**PLANNED UNIT DEVELOPMENT
& SUBDIVISION STAFF REPORT****Date: April 5, 2007****DEVELOPMENT NAME**Grande Oaks at Hillcrest Subdivision *and Lot A of the Oaks Subdivision***SUBDIVISION NAME(S)**Grande Oaks at Hillcrest Subdivision
and
*Lot A of the Oaks Subdivision***LOCATION**2709 Hillcrest Road
(East side of Hillcrest Road, 340'± North of Shady Lane,
and the landlocked parcel located 140'± North of the right-
of-way of Weddington Court, and 520'± East of the right-
*of-line of Hillcrest Road)***CITY COUNCIL
DISTRICT**

AREA OF PROPERTY*PUD: 6.3 ± acres*
Grande Oaks Subdivision: 12 Lots / 5.2 ± acres
*Lot A of the Oaks Subdivision: 1 Lot / 1.1 ± acres***CONTEMPLATED USE***Planned Unit Development* to allow a 13 lot residential subdivision with a gated private road, and *Subdivision* approval to create one twelve (12) lot subdivision, and a one (1) lot subdivision.**TIME SCHEDULE
FOR DEVELOPMENT**

SITE PLAN

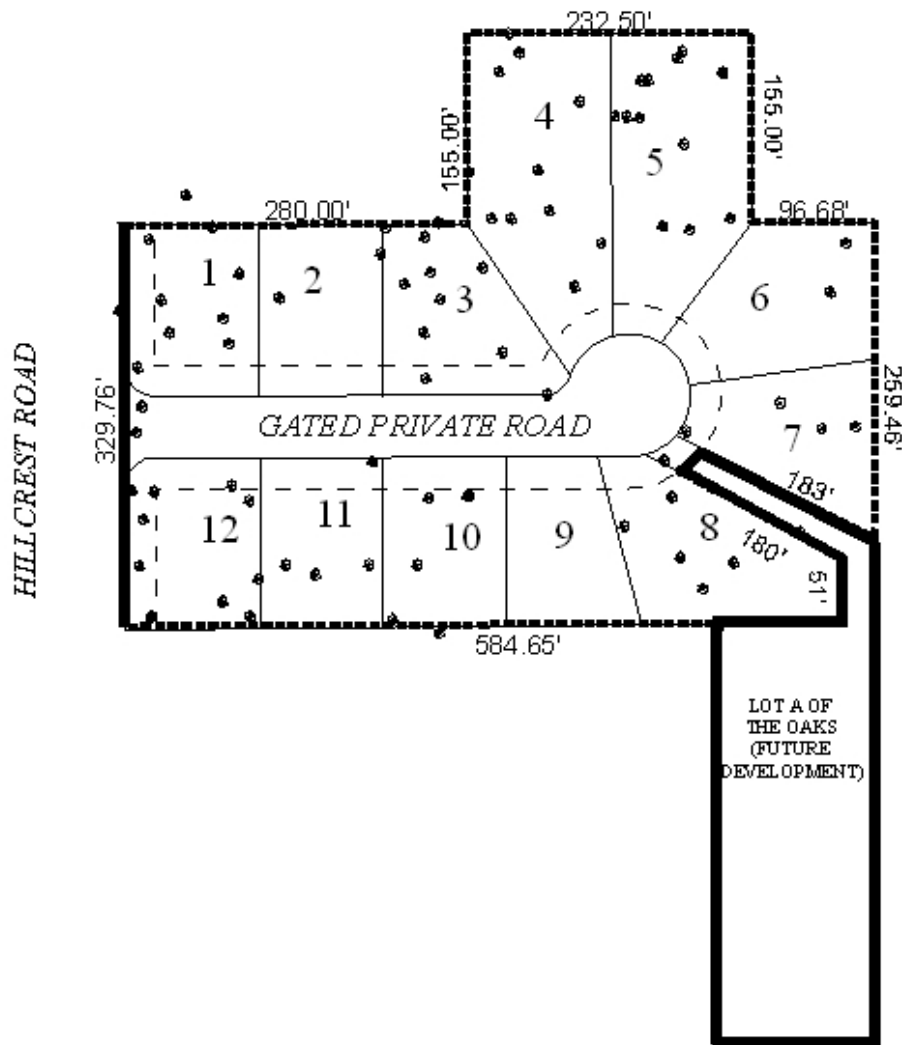
The site fronts Hillcrest Road, a planned major street with an adequate 100-foot right-of-way. As Hillcrest Road is a major street, access management is a concern. Proposed Lots 1 and 12 should be denied direct access onto Hillcrest Road. Also, the gate for the proposed private street may need to be moved further from Hillcrest so that traffic turning into the development will not stack-up into Hillcrest Road.

All of the lots appear to meet the minimum dimensional requirements of the Subdivision Regulations, however, the plat and PUD site plan should be revised to include the size of each lot in square feet as either a note on each lot, or as a table. It should be noted that there do not appear to be any requests by the applicant for reduced setbacks or increased site coverage, thus the standard requirements for R-1, Single-Family Residential districts will apply.

Finally, the PUD site plan and Subdivision plat do not depict any area set aside for detention. As PUD approval is site plan specific, and as the Subdivision plat may need to show any detention as common area, both the site plan and plat should be revised to depict a detention area for the development.

The revised site plan does not depict any area set aside for storm water detention. If a storm water detention area is required by the Engineering Department the site plan and subdivision plats should be revised accordingly.

Regarding the Lot A Subdivision, a note should be placed on the final plat, if approved, stating that no future subdivision of the lot is allowed until additional street frontage is provided. Also, the minimum building setback line should be depicted on the plat and the combined PUD site plan where the property is at least 60 feet in width. The size, design and location of any curb-cuts for this lot must be approved by Traffic Engineering and Urban Forestry, and comply to the greatest extent possible with AASHTO standards.

Regarding the Grande Oaks at Hillcrest Subdivision, Lots 1 and 12 should be denied access onto Hillcrest Road. The size, design and location of any curb-cuts for the subdivision must be approved by Traffic Engineering and Urban Forestry, and comply to the greatest extent possible with AASHTO standards. The design and location of the private street, and the design of the access onto Hillcrest Road must also be approved by Traffic Engineering.

Planned Unit Development: Based upon the revised PUD site plan, this application is recommended for Approval, subject to the following:

- 1) revision of the PUD site plan and Subdivision plats to depict a detention common area, if required, and labeling of the detention common area and placement of a note on the PUD site plan and plats stating ;

- 2) completion of the Subdivision process for the Grande Oaks at Hillcrest Subdivision and the Lot A of The Oaks Subdivision;
- 2) compliance with Section VIII. of the Subdivision Regulations, regarding the provision of a private street;

- 3) designation on the PUD site plan of utility easements acceptable to the appropriate provider of utility services within the subdivisions;
- 4) placement of a note on the PUD site plan stating that the street is privately maintained and not dedicated to the public;

- 5) placement of a note on the PUD site plan stating that if the private street is not constructed and maintained to the appropriate City standard, and is ultimately dedicated for public use and maintenance, 100 percent of the cost of the improvements required to bring the street up to the prevailing standard shall be assessed to the property owners at the time the private street is dedicated, with the assessment running with the land to any subsequent property owners;

- 6) placement of a note on the PUD site plan stating that the gate must remain operational and in use as a condition of the continuation of private street status,

- 9) depiction of the minimum building setback line for Lot A of the Oaks, where the lot is at least 60 feet wide;
- 10) provision of two (2) revised PUD site plans to the Planning Section of Urban Development prior to the signing of any Subdivision plats; and
